ADDENDUM No. 2
LUC – CORDUORY ROAD AND WYNN ROAD RESURFACING
PID 118110

CITY OF OREGON
DEPARTMENT OF PUBLIC SERVICE

CONTRACT CHANGES

SUB SUMMARIES

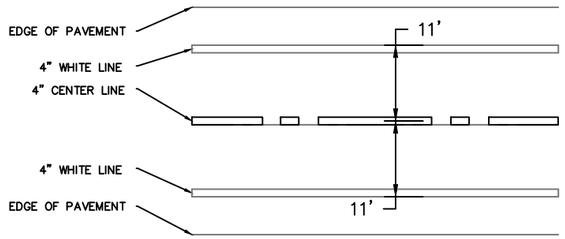
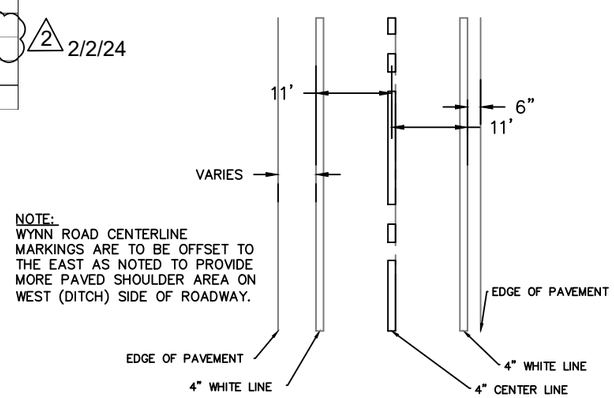
NOTE:
WYNN ROAD CENTERLINE MARKINGS ARE TO BE OFFSET TO THE EAST AS NOTED TO PROVIDE MORE PAVED SHOULDER AREA ON WEST (DITCH) SIDE OF ROADWAY.

PARTIAL DEPTH CONCRETE JOINT REPAIR DETAIL

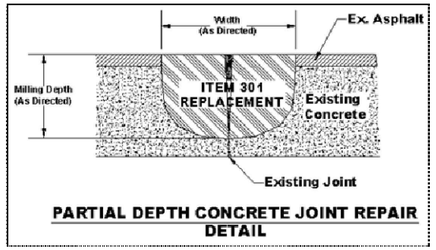
- **Question #4 – Are milled joints an acceptable alternative to sawing for spot base repairs?**

Yes, milled joints are acceptable. See detail on Sheet 8.

TYPICAL SECTION

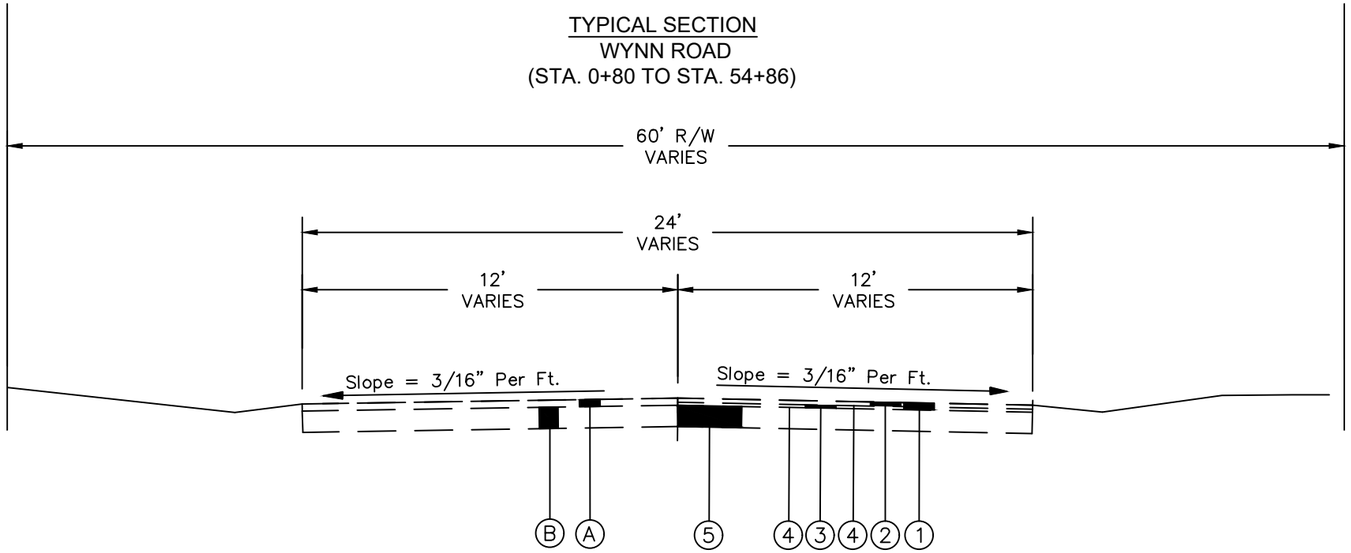
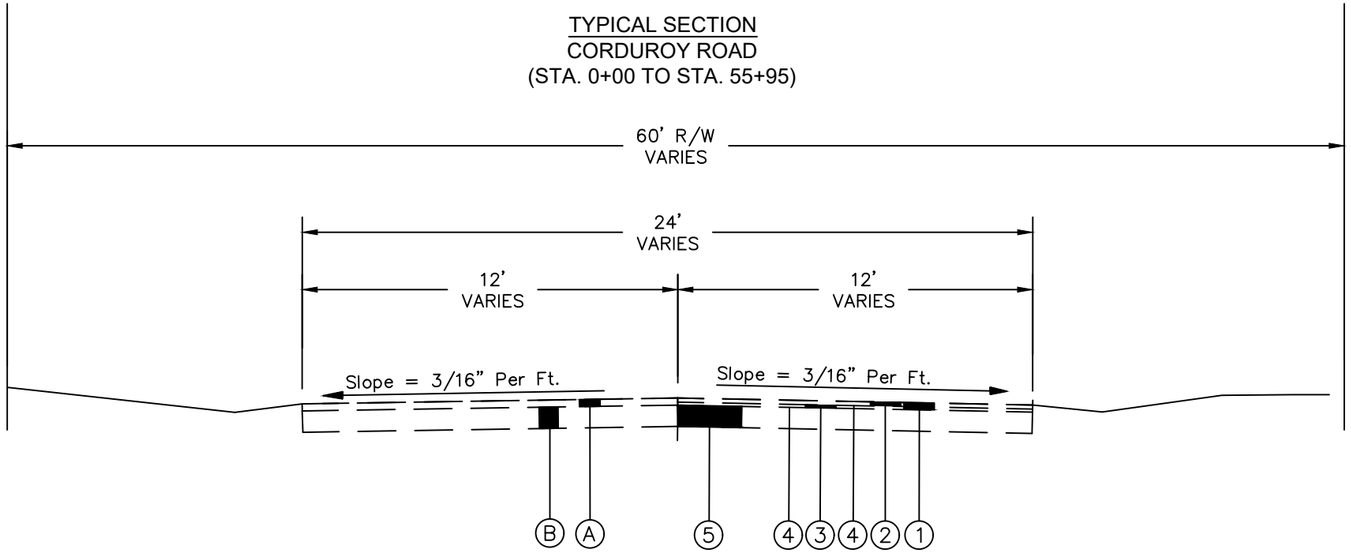
- **Question #3 – If spot base repairs are directed on Corduroy Rd is the intent to perform repairs down to the concrete, partially into the concrete or down to the subgrade? Excavation methods differ depending on intended depth.**

Spot repairs are intended to be partial depth. Milling will not be performed to a depth that would reach any reinforcement.

NOTE: FOR CONCRETE DRIVEWAYS THAT ARE TO BE SAW CUT BACK AND REMOVED, 4.5" ITEM 441 TYPE 2 SHALL BE FEATHERED IN WITH THE INTERMEDIATE COURSE AND 1.5" ITEM 441 TYPE 1 SHALL BE FEATHERED IN WITH THE SURFACE COURSE. MAINTAIN DRIVEWAY ACCESS WITH GRINDINGS FOLLOWING REMOVAL UNTIL ASPHALT IS PLACED, WHICH SHALL BE CONSIDERED PART OF THE MOT ITEM.
